Safety Defect and Noncompliance Report Guide for Vehicles
PART 573 Defect and Noncompliance Report
2009 APR 15 P 1:58

Make(s): Orion **Model Years Involved:** 2008 - 2009 **Model(s):** VII

Subject: 15-19182 Blower motor and resistor hardware torque

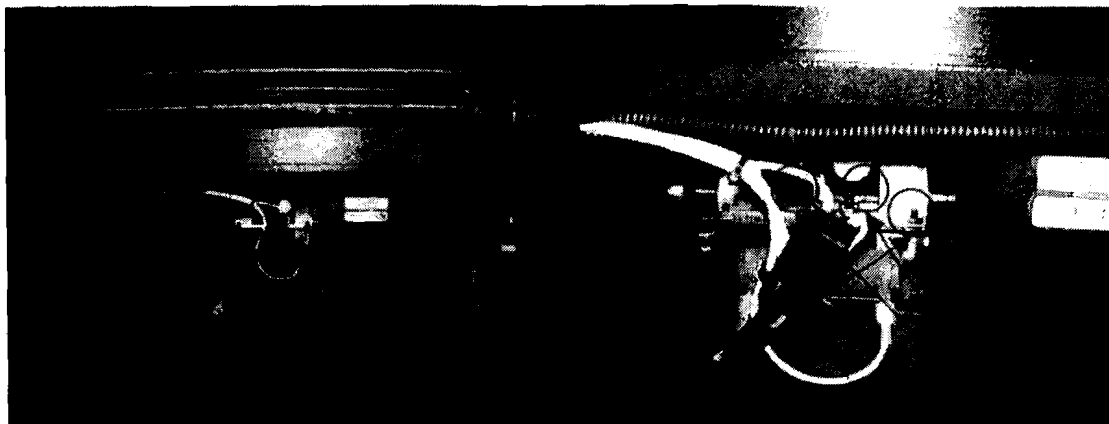
During the production of blower 15-19182 between Oct. 2008 and Mar. 25, 2009 the intended torque of the motor and resistor mounting screws may not have been applied correctly.

Resistor screws

motor screws

motor screws

Apply the intended torque values on the 4 x 10-32 blower motor mount screws and the 2 x 8-32 resistor mount screws in the 2 x lower floor heaters and the front defroster.

10-32 screw torque is 38 in lb blower motor mounting

8-32 screw torque is 30 in lb resistor mounting

- 5) Record if bolts are loose or stripped
(Loose definition < 30 in lb for 10-32 screw & < 23 in lb for the 8-32 in lb)
- 6) Record date of manufacture
- 7) Record number on green inspection sticker
- 8) Remove 2 x 8/32 screws securing the resistor and retain for re-installation
- 9) Apply a torque of 38 in. lb. to 4 x 10-32 screws using the torque wrench and a 5/16" socket and 10mm wrench

- 10) Re-install the resistor using 2 x 8/32 screws.
- 11) Apply a torque of 30 in. lb. using the torque wrench and a 1/4" socket and 8mm wrench
- 12) Apply torque seal to the heads of all 6 screws
- 13) Re-assemble floor heater in reverse order.
- 14) Record all data required on tracking sheet
- 15) Apply "GREEN DOT" sticker on the exterior of the completed floor heaters
